**SB-10046779-8758**SI M17 06 12  
Cooling SystemsDecember 2012  
Technical Service

This Service Information bulletin supersedes SI M17 06 12 **dated October 2012.**

**SUBJECT****Service Action: Retrofit of the Engine Coolant Temperature Sensor****MODEL**

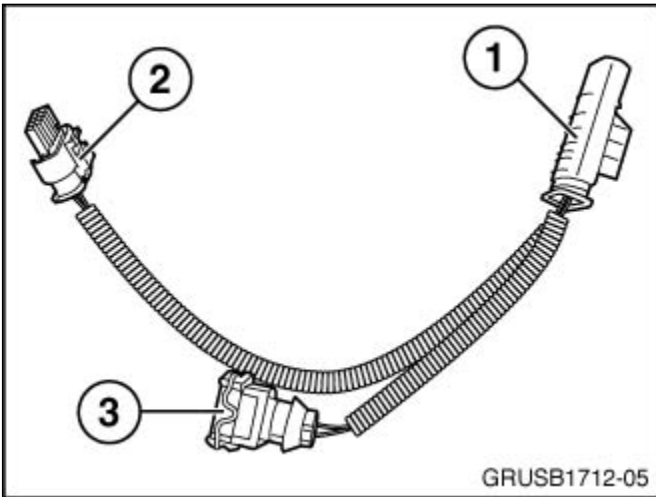
Install the new coolant hose with sensor P/N 17 12 7 647 004 (1).

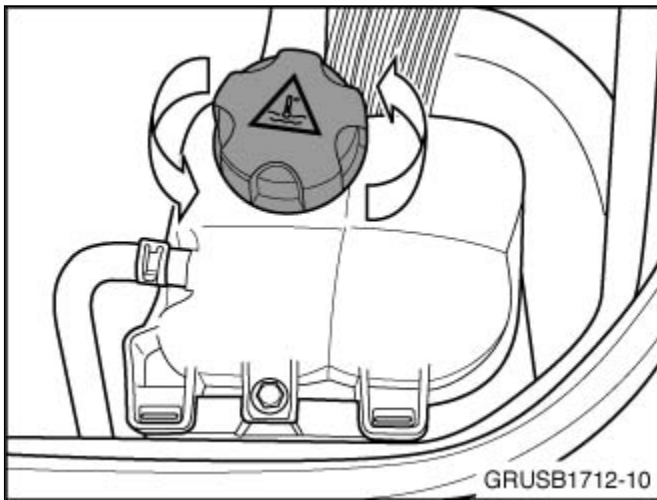
The improved sensor (P/N 13 62 8 603 908) includes the temperature probe (1) and insulating sleeve (2), a two-pin female connector (3) for the map thermostat, and a four-pin connector (4) for the engine harness.

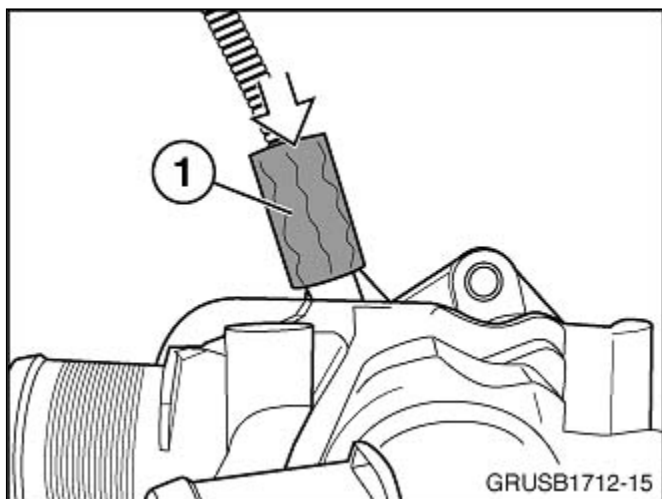
The back of the temperature sensor is slotted to accept a bladed screwdriver (1). Install the sensor into the bleeder screw hole, and torque to 2Nm.
